ADDENDUM NO. 1

SOLICITATION NO. 220020 OLD VAIL MIDDLE SCHOOL, MARY ANN CLEVELAND WAY, VAIL (4OLVMS). MARY ANN CLEVELAND WAY AT KUSH CANYON LANE, TUCSON (4TAMAC)

This Addendum addresses questions raised through 4:00 PM on June 13, 2016, and at the pre-bid conference of June 7, 2016. This Addendum shall be incorporated and made part of the Bid Documents as though included therein. **This addendum is 29 pages.**

Appendix E Standard Detail 105 revised 09/15 HANDRAIL (ATTACHMENT 3) (2 pages)

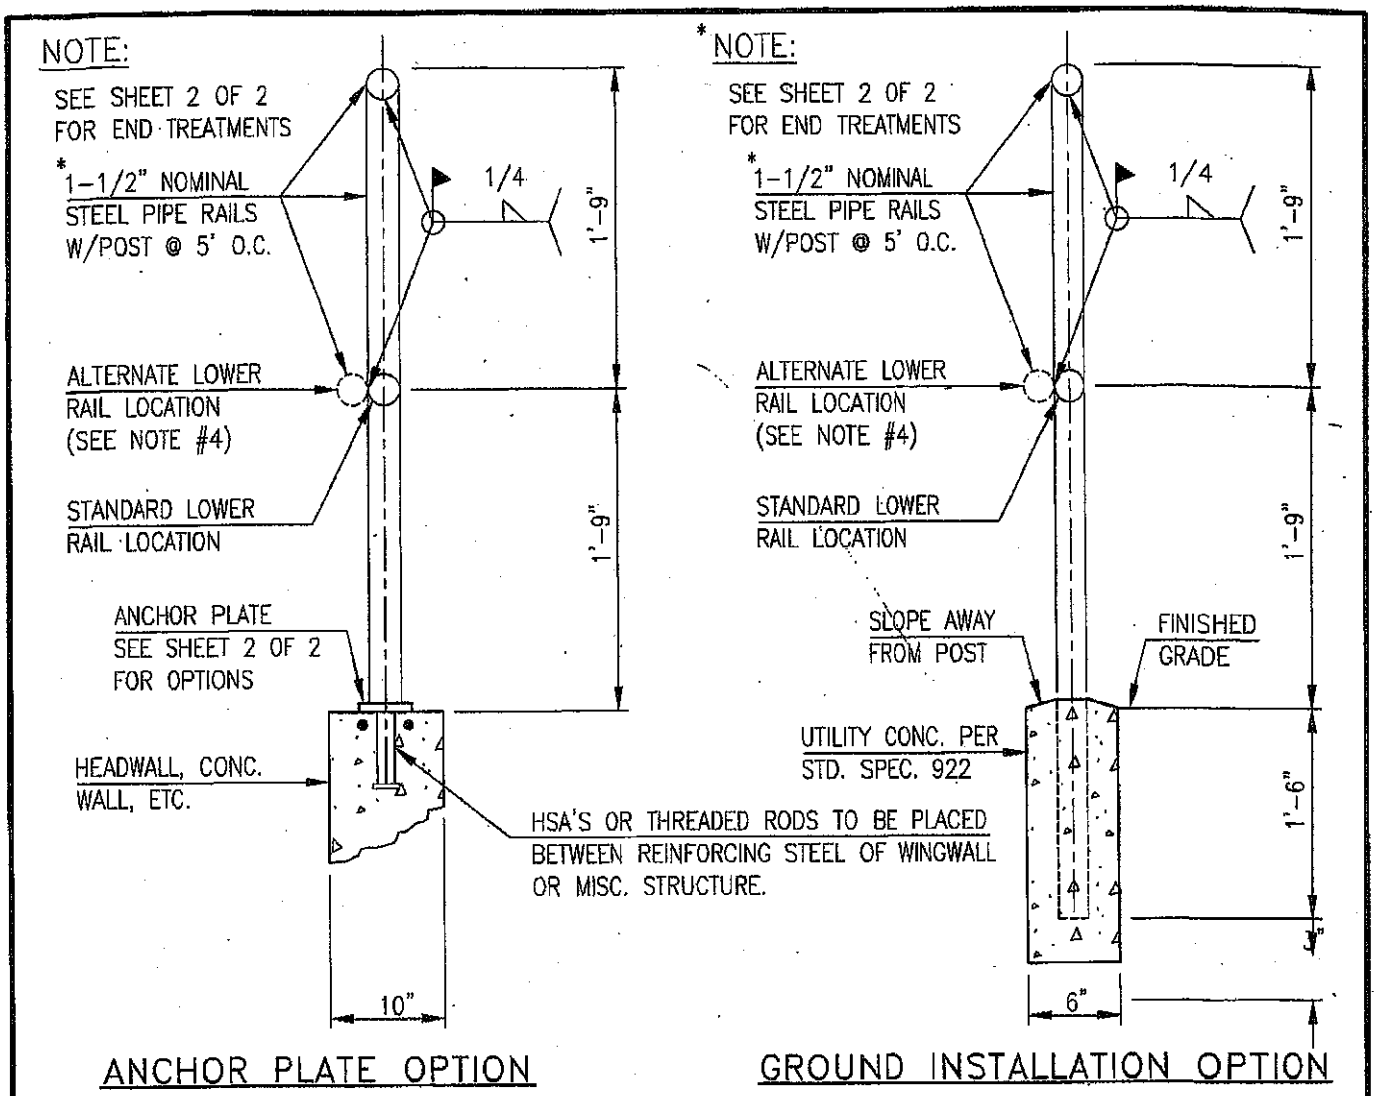
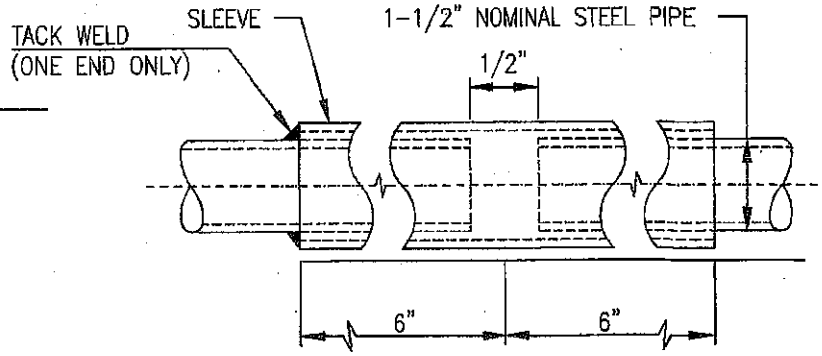
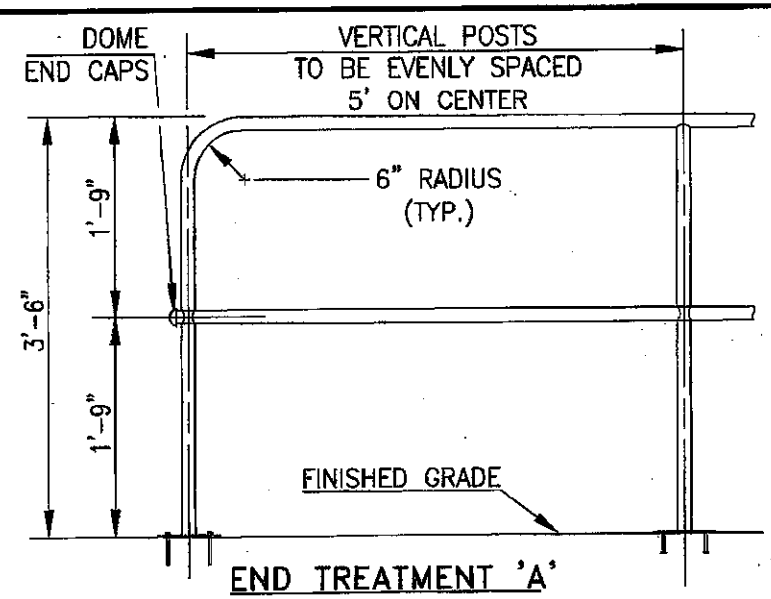
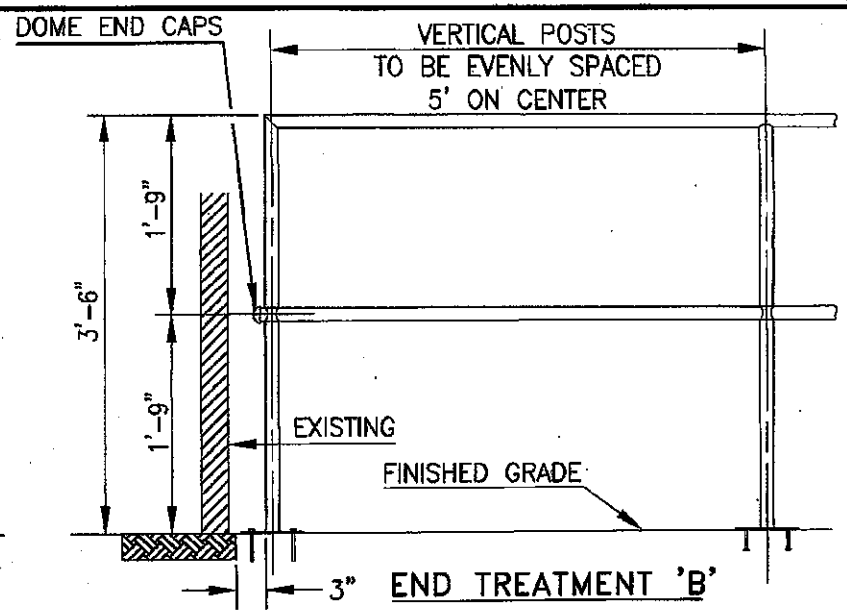
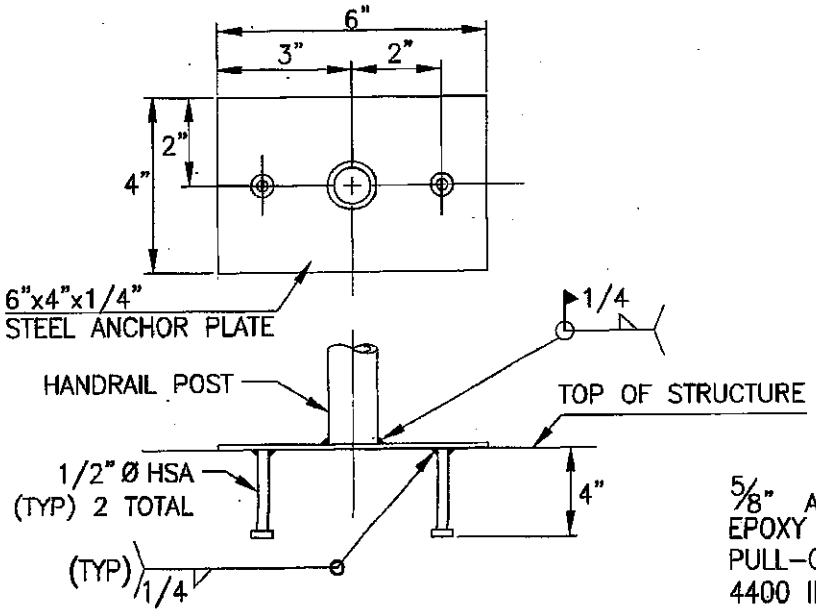
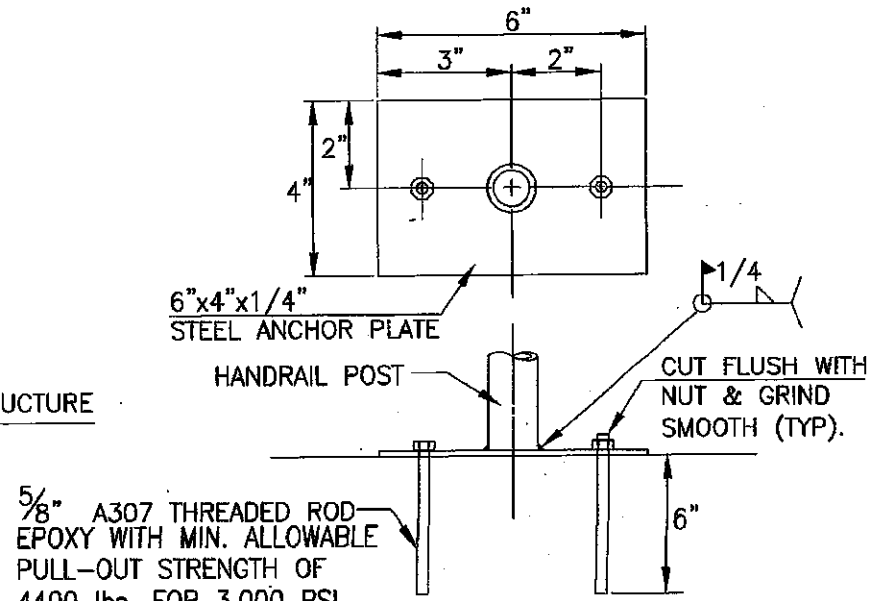
Delete: Item 9330002 Handrail (Detail G, Sheet 5)
Add: Item 9330002 Handrail; Unit: L.F.; Quantity 1,300
